Riley Purgatory Bluff Creek Watershed District Permit Application Review

Permit No: 2020-061

Project: Purgatory Creek 2nd Addition: The project is a 3.07 acre, 7-lot single family residential development that will disturb 2.95 acres. Stormwater management will be provided by two rain gardens and two detention/rock infiltration trenches to provide volume control, water quality, and rate control.

Reviewer: Scott Sobiech P.E., Barr Engineering

SHEET NO.: C01

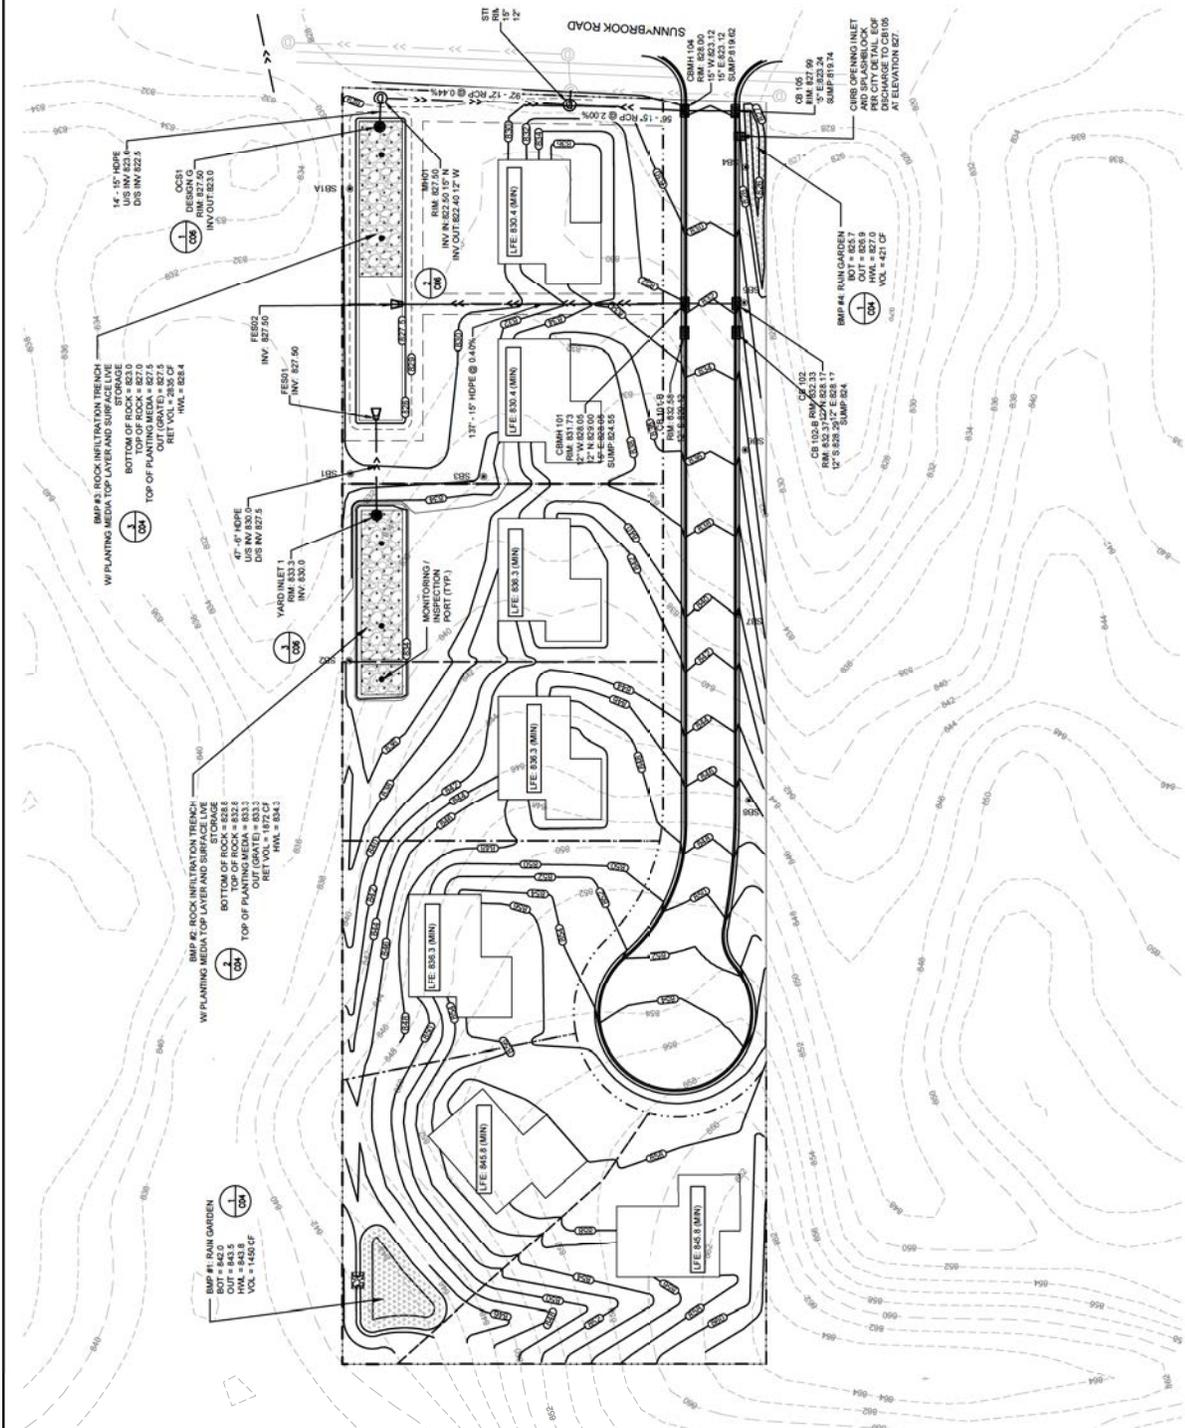
J1. The stormwater narrative indicated the bottom of the northern detention/rock infiltration trench was raised to elevation 830.5 feet in response to comments and to provide 3 feet of separation to the groundwater, which is confirmed by the cross section on sheet C04. However, plan sheet C01 indicates the bottom of the facility remained at elevation 828.8 feet. The applicant must provide an updated grading plan demonstrating 3 feet of separation to groundwater.

- b. Revisions to the grading plan to show the bottom of the northern detention/rock infiltration trench raised to elevation 830.5 feet for consistency with the response to comments the cross section on sheet C04.
